Access Compliance Report

Public Rights-of-Way

| Intersection ID: 50538 | Main Street: CAYENNE_DR | Cross Street: CILANTRO_WY | Location: NW |
| ADA ID: 88DF2CA9CE64 | Ramp Type: PerpDiag | Initial Pass/Fail: Fail | Overall Compliance: No |

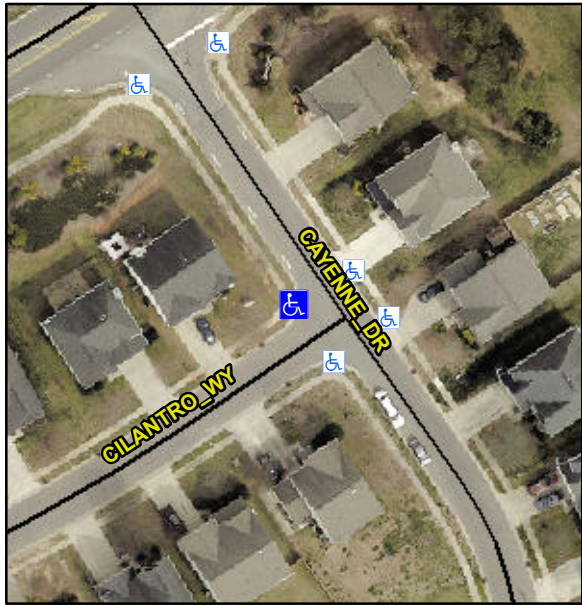
| Codes/Mitigation Info/Possible Solution | | | Field Measurements/Component Compliance | | | | | |
|--|---|-------------|---|-----------------------|------|------------|-----------------------------|------|
| | Remove & Replace Curb Ramp With Two New Directional Ramps or Equivalent. | | N/A | Ramp Length (in) | 51.5 | Yes | Ramp Slope (%) | 7.3 |
| | | | No | Ramp Width (in) | 47.0 | No | Ramp XSlope (%) | 5.2 |
| Not Found, R304.5.1, R304.5.3 | | | N/A | Gutter Lip Ht (in) | N/A | N/A | Gutter X Slope (%) | N/A |
